REGISTRY OF RADIOACTIVE SEALED SOURCES AND DEVICES
SAFETY EVALUATION OF DEVICE

NO: AZ244S102B DATE: October 10, 2002
(Supersedes AZ-0806-S-118-G and AZ 244D102S)

DEVICE TYPE: Radioluminous Calibration Light Source

MODEL: 40111

40111

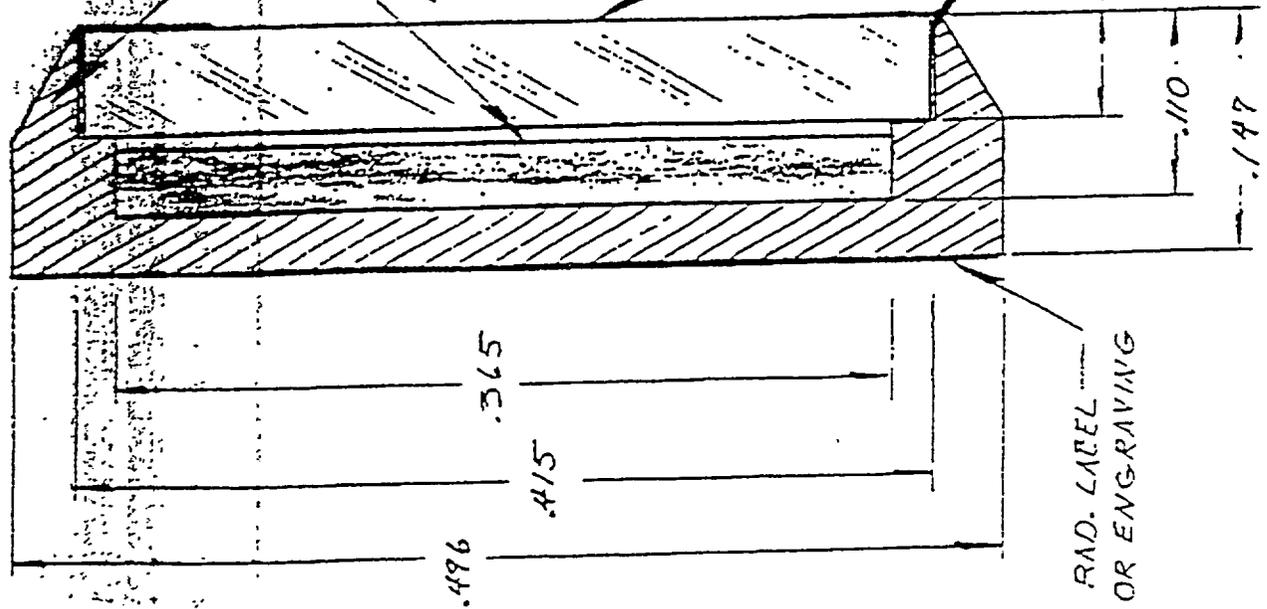
The AAC Model 40111 and the TLS Systems, Inc. Model 40108A Sources, based on drawings (Enclosures 2 and 3) are for all practical purposes identical, the latter model having current registration by this Agency. A suggestion would be to amend the Model 40108A registration to include the Model 40111.

Although the models seem to be very similar, the information provided by the State indicates the AAC Model 40111 is not identical to the TLS Model 40108A. We have been unable to obtain additional information from our files that would indicate that these sources are identical in design and construction.

The AAC Model 40111 sources should not be re-labeled as the TLS Model 40108A sources as these sources were manufactured by AAC and not TLS Systems, Inc. Licensing of these sources is based on the approval issued to AAC. Since there is currently no information that would indicate that these model sources are identical in design and construction, re-labeling the sources would invalidate that approval.

The ARRA amend an existing inactive source certificate issued to AAC to add the model 40111 source. This would be based on the information that ARRA currently has available, and would provide a basis for licensing the source for use. Also, this would be a lesser administrative burden than issuing a separate certificate for the 40111 source. When choosing a certificate to amend, the State should consider only certificates for source models similar in design, construction, and use to the model 40111 source (e.g., AZ-0806-S-118-G, for the 40108 I-lite source). The amended certificate should contain a listing of all known limitations of use for the model 40111 source (such as environmental use conditions or types of uses). Information provided by the State, TLS Systems, Inc., and Northrop-Grumman Corporation (an Air Force contractor who installs the sources) indicates the AAC model 40111 source was approved for uses similar to the currently registered TLS model 40108A I-Lite source. Therefore, wording in the current certificate for the model 40108A I-Lite source could be used as a basis for wording in the model 40111 source certificate.
